Technical product information

Topic	Audio amplifier failure - water leak
Market area	Bentley: worldwide (2WBE),Hongkong-Macau (5HK)
Brand	Bentley
Transaction No.	2044285/1
Level	EH
Status	Approval
Release date

Mulsanne

Figure 1

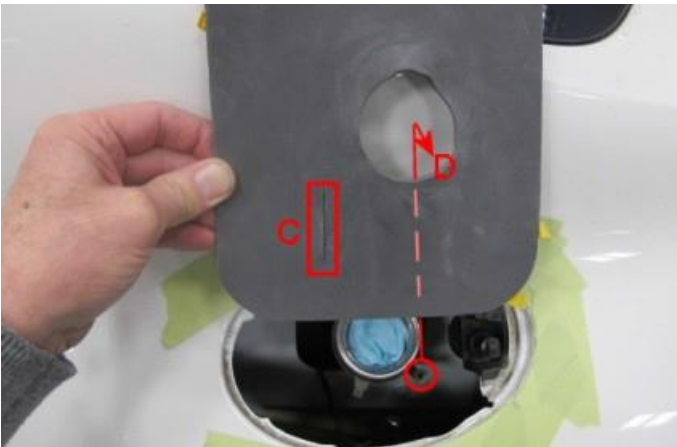
2. Clean surface of inner panel (A) in preparation for affixing water deflector (see Figure 1)
3. Disconnect earth wire (B) from fuel filler neck (see Figure 1)

Figure 2

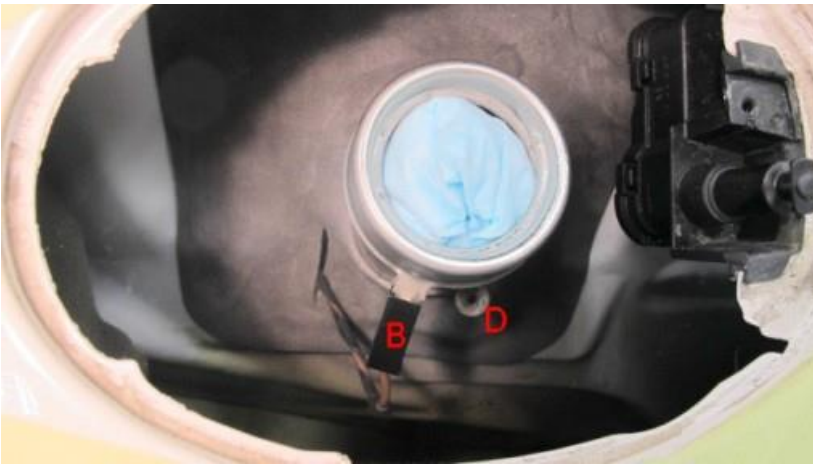
4. Position water deflector (part number 3Y0813725) over filler fuel filler neck, threading the earth wire through slot (C) and the fuel filler drain tube through the main hole at point 'D' (see Figure 2)
5. With the water deflector in position remove adhesive tape backing paper using easy peel off tabs and press water deflector in position to inner panel
